MILITARY SPECIFICATION

BURNER, CARBON MONOXIDE AND HYDROGEN, CATALYTIC TYPE (MARK V)

This amendment forms a part of Military Specification MIL-B-24535(SH), dated 6 April 1976 and is approved for use by the Naval Sea Systems Command and is available for use by all Departments and Agencies of the Department of Defense.

FIGURE 1. Weight, overall dimensions and mount location.

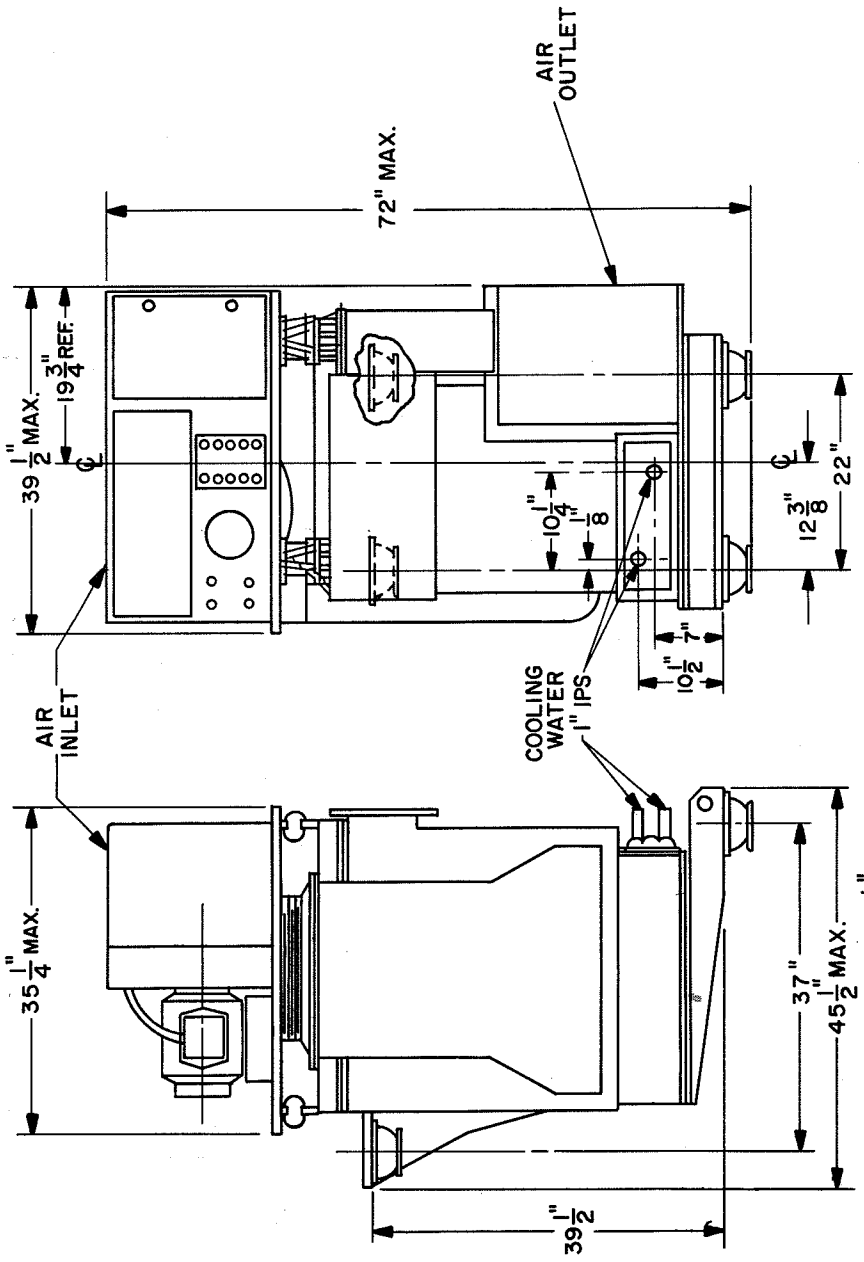
Figure 1: Delete and substitute the attached figure 1.
